Access Compliance Report

Public Rights-of-Way

Intersection ID: 21132	Main Street: W_ARROWWOOD_RD	Cross Street: SOUTHERN_PINE_BV	Location: S
ADA ID: 2F0AF667658A	Ramp Type: PerpDiag	Initial Pass/Fail: Pass	Overall Compliance: No
		Severity Score: 15

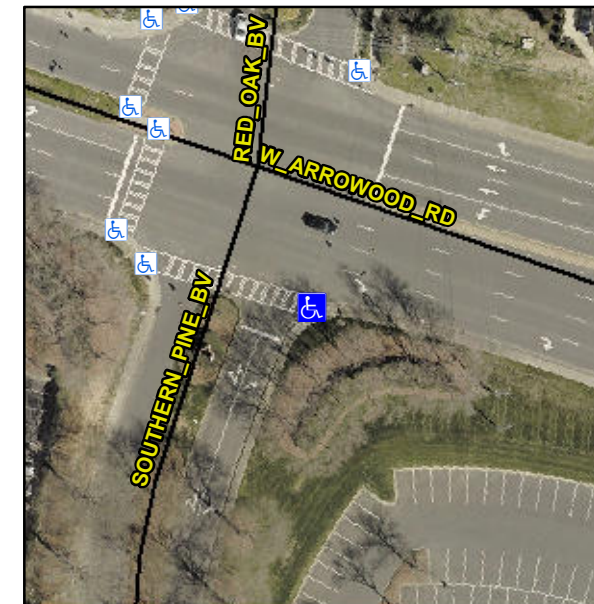
Not Found, R304.2.1, R304.2.2-Perp, R304.3.2-Para, R304.5.3, R305.2, R304.5.4

Compliance	Description	Data	Compliance	Description	Data
N/A	Ramp Length (in)	63.0	Yes	Ramp Slope (%)	6.8
Yes	Ramp Width (in)	54.0	Yes	Ramp XSlope (%)	0.7
N/A	Flare Type LT	Sloped	N/A	Flare Type RT	N/A
N/A	Flare Slope LT (%)	6.5	Yes	Flare Slope RT (%)	4.4
N/A	Flare Traversable LT?	Yes	N/A	Flare Traversable RT?	Yes
No	Landing Length (in)	N/A	Yes	DWS Provided?	Yes
No	Landing Width (in)	N/A	Yes	DWS Contrast?	Yes
No	Landing Slope (%)	N/A	Yes	DWS Length (in)	24.0
No	Landing X Slope (%)	N/A	Yes	DWS Full Width?	Yes
N/A	Landing Curb? (Y/N)	No	No	DWS Offset (in)	5.0
N/A	Shared Landing?	No			
Yes	Gutter Ponding?	No	No	Gutter Slope (%)	5.8
Yes	Gutter Lip Ht (in)	0.0	Yes	Gutter X Slope (%)	0.1
N/A	Painted X Walk1?	No	N/A	Painted X Walk2?	Yes
	X Walk 1 Direction	To NE		X Walk 2 Direction	To NW
N/A	X Walk 1 Width (in)	N/A	N/A	X Walk 2 Width (in)	110.0
	X Walk 1 Slope (%)	0.9		X Walk 2 Slope (%)	2.1
	X Walk 1 X Slope (%)	3.0		X Walk 2 X Slope (%)	0.2

N/A	Ramp inside XWalk1?	N/A	Yes	Ramp inside XWalk2?	Yes
	Road Slope (%)	2.2	N/A	Clear Space?	Yes
	Road X Slope (%)	2.5	N/A	Clear Space to XWalk (in)	N/A
Yes	Any Obstructions?	No	Yes	Storm Grate/Utility Hazard?	No
	Obstruction Type			Storm Grate/Utility Type	
		N/A			N/A
			Yes	Surface Condition? (G/P)	Good

Remove & Replace Curb Ramp With Two New Directional Ramps or Equivalent. Remove & Replace Gutter.
